**NATIONAL RAILROAD PASSENGER CORPORATION
NORTHEAST CORRIDOR
NEW YORK - WASHINGTON
SUMMARY BULLETIN ORDER No. NYW1-19SUM
Effective 12:01 AM, Monday, August 4, 2025**

New York - Washington Bulletin Order(s) in effect: NYW1-19SUM

INDEX OF RULE / SI CHANGES OR MODIFICATIONS CONTAINED IN THIS BULLETIN ORDER

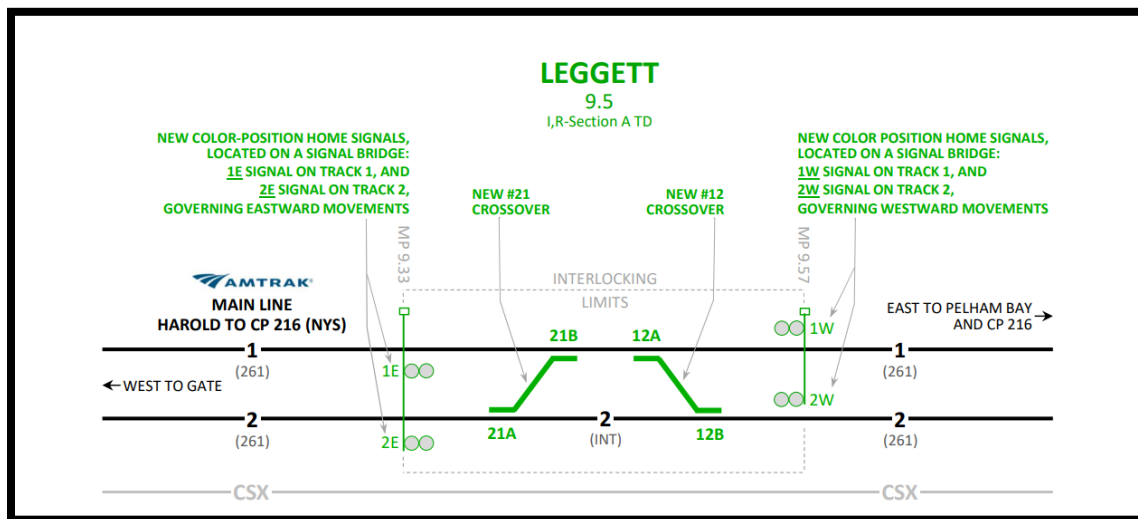
Signals 90-1 and 90-2 are removed from service and bagged.

The existing automatic signals (90-1 and 90-2) governing eastward movement on No. 1 & No. 2 Trks at MP 9.09 are bagged and removed from service.

2. AC Motor Stop Signs

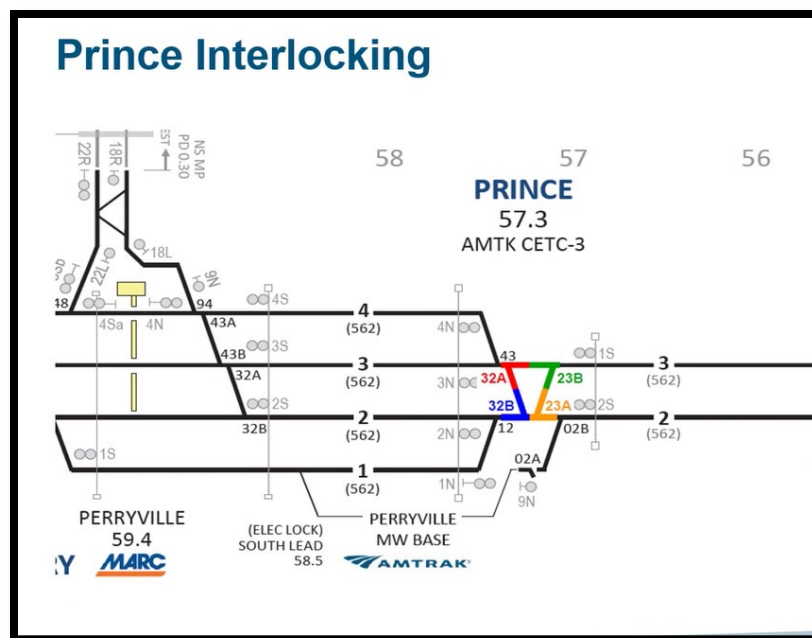
- AC Motor Stop Signs have been erected on No.3 track and located 175 feet south of the No. 43 switch at Paul (31 feet north Pole D1313) and 109 feet north of the No. 13 switch at Charles (Pole D1325).
- AC Motor Stop Signs have been erected on No. 1 track and located 956 feet south of the No. 61 switch at Paul (Pole D1311) and 216 feet north of the No. 13 switch at Charles (Pole D1324).

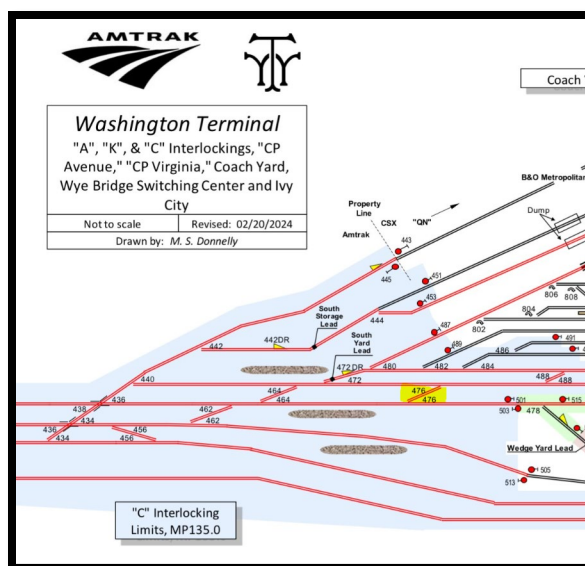
To help prevent derailments, equipment damage, and stop signal violations caused by improperly lined switches or fouling the track, new safety aids have been installed. These aids are intended to raise awareness but do not reflect the actual position of the switch or confirm that it is properly lined.

- Amber Reflector “Lights” are being installed throughout Washington Terminal at fouling points. These lights are attached to the top of the railroad tie and indicate the clearance point of a switch.
- In some locations the Letters “FP” will be stenciled next to the fouling point.
- White Solar Powered “Lights” are being installed at switch points are attached outside the rail on the railroad tie.
- White Reflector “Lights” and reflective red and white poles are being installed adjacent to dwarf Signals.
- These are directional and reflect light when encountered by a train or on-track equipment. The “Lights” do not reflect light when it comes from wider angles, preventing the distraction of adjacent track movements.

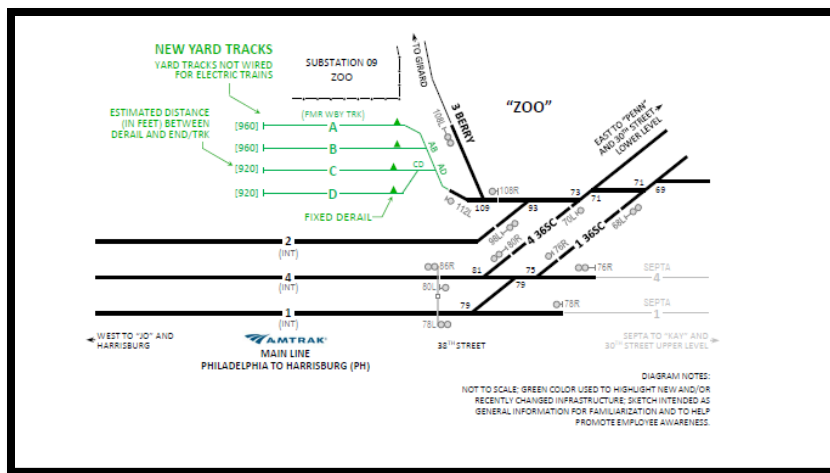
Zoo Yard is new, Zoo Yard is located within Zoo Interlocking at MP 2.3

Previous Track Designation	New Track Designation	Total Length
WBY	A Track	960 Feet
	B Track	960 Feet
	C Track	920 Feet
	D Track	920 Feet

H. *PC: Caln Int

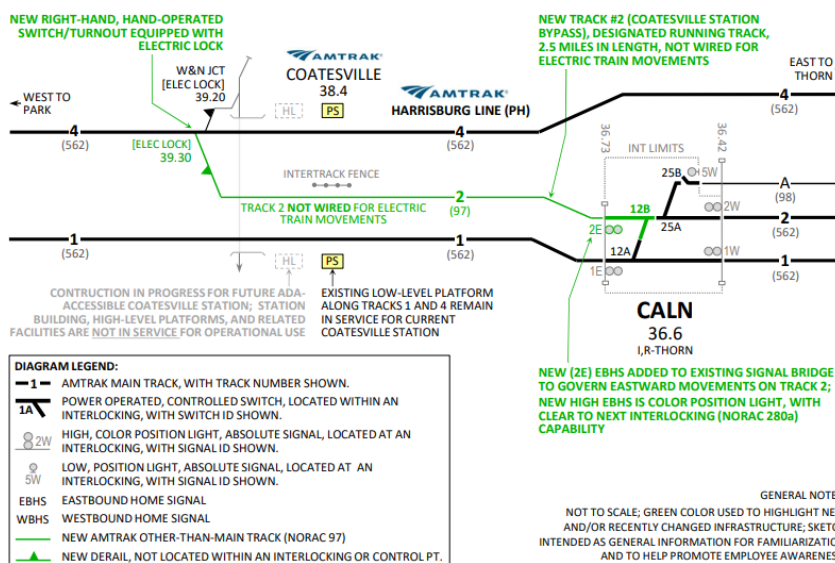
Caln Int map is modified. Letter A Trk Movement is a Track Not Governed by ABS, DCS or Interlocking Rules (Rule 98). The 2E signal is modified from Clear Block to Clear to the Next Interlocking.

- **5W Signal**

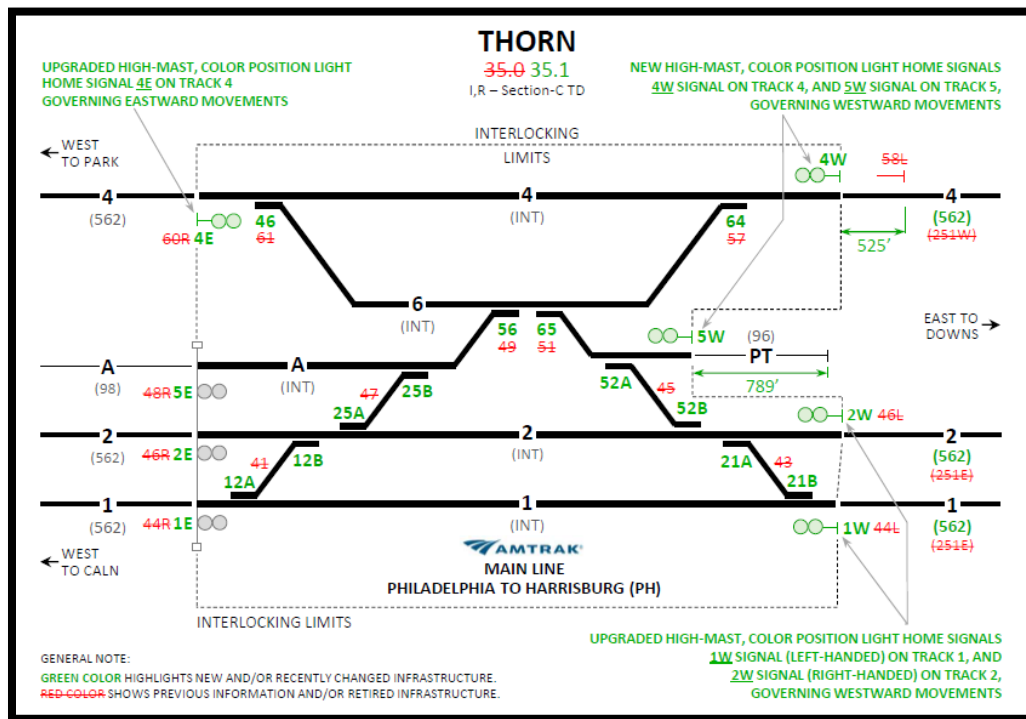
The 5W Home Signal is New and located 789 ft west from the “End of Track.”

This signal governs westward movement out of “PT” stub end track. The 5W is a color position mast signal with clear block capability, capable of displaying the following aspects:
